Consultation report of the public consultation on the scenario's, sensitivities and data for the CRM parameter calculation for the Y-1 Auction with Delivery Period 2025-26 and Y-4 Auction with Delivery Period 2028-29

June 2023

Figure 3: Historical evolution of the capacity factor of profiled CHP units generation in Belgium

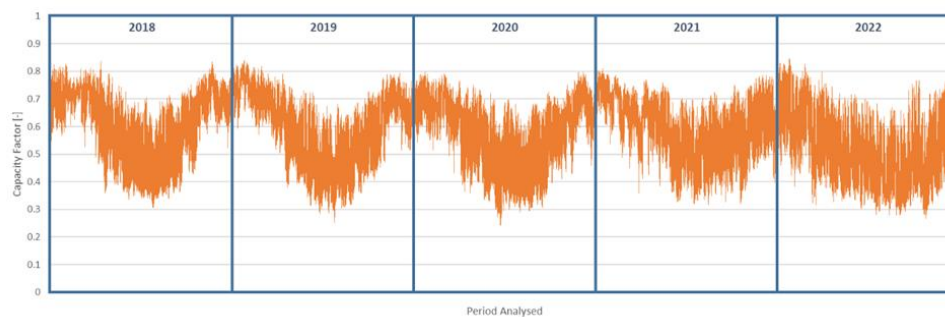
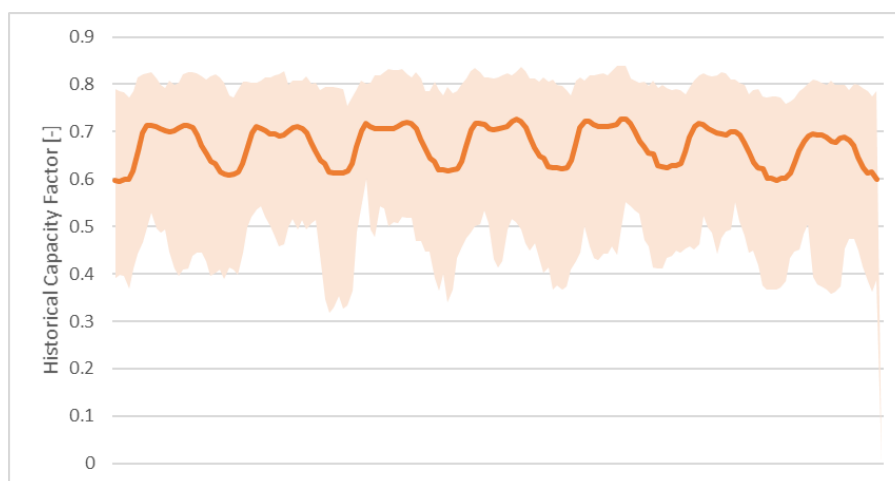
Regarding Febeliec's comment on the evolution of CHP, it is important to highlight that most of the current CHP installations are situated in Flanders. However, it is anticipated that many of these installations will no longer receive subsidies in the upcoming years. However, CHP units can still participate to the CRM auctions. Therefore, the trajectory assumed by Elia considers all the existing capacity and all the known mature projects.

The CHP and the biomass units that are not individually modelled are considered as profiled thermal generation. They are considered as full must-run according to a predefined profile, meaning that the production is to be considered fixed whatever the economic dispatch. This profile is determined based on historical metering data and has been updated in the framework of AdeqFlex'23 to better reflect the potential of the technology.

More precisely, for the aggregated profiled biomass and waste units, the latest analysis of the measurement data has shown no clear seasonal trend. A constant production profile of 60 % of the installed capacity is therefore considered. For the aggregated CHP, the available power output measurement data was analysed for the period 2018-2022 and clearly shows a seasonal and weekly trend as can be observed on Figure 3 and Figure 4 respectively. The profiles for aggregated CHP used in the simulations are based on the historically observed profiles.

Figure 8 : Load evolution assumed in Belgium and other countries normalised to 2022 (excluding electrolysis)

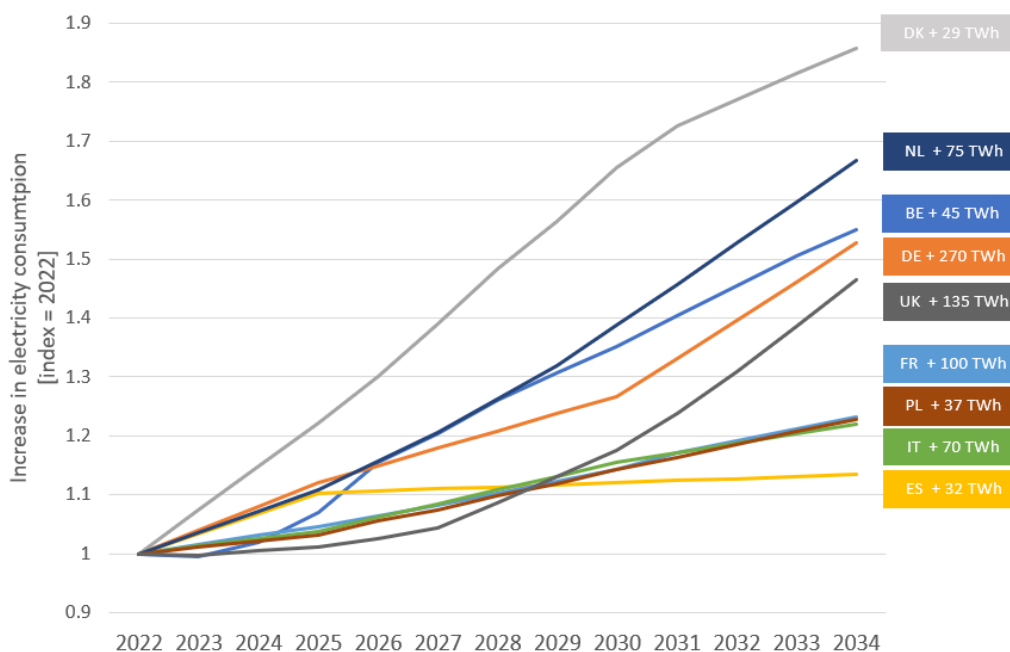
<p>It is surprising to observe that, with the exception of Denmark, Elia proposes with +18% the largest relative increased in demand of all observed countries (and Denmark has a much lower absolute consumption level, skewing the relative increase), while most other countries, facing the same European legislation and goals and impact on electrification, show only single digit increases over the period 2025-2029 (in the case of Spain even only +1%). In this perspective, Febeliec can only question Elia’s potentially overambitious proposed values, which however have a very clear impact on adequacy needs and concerns and thus also on the overall system cost as this could lead to additional but unwarranted costly CRM capacity needs.</p>	Demand (TWh)	2025-2026	2028-2029	% increase	Belgium	88,7	104,4	18%	France	480	506	5%	Germany	574	619	8%	Netherlands	124	141	14%	UK	295	316	7%	Spain	259	261	1%	Italy	329	342	4%	Poland	167	178	7%	Denmark	41	50	22%
Demand (TWh)	2025-2026	2028-2029	% increase																																						
Belgium	88,7	104,4	18%																																						
France	480	506	5%																																						
Germany	574	619	8%																																						
Netherlands	124	141	14%																																						
UK	295	316	7%																																						
Spain	259	261	1%																																						
Italy	329	342	4%																																						
Poland	167	178	7%																																						
Denmark	41	50	22%

The Figure 8 shows the electricity consumption trends in Belgium and in several other significant European countries. It is worth noting that the figures exclude electrolysis. The information depicted in the figure is derived from the latest national studies and the ERAA 2022 dataset with adjustments made to account for the energy crisis. Upon analysing Figure 8, it becomes apparent that Belgium's projected increase in electricity demand aligns well with other major countries (and interconnected countries) such as Germany, the Netherlands, and the UK.
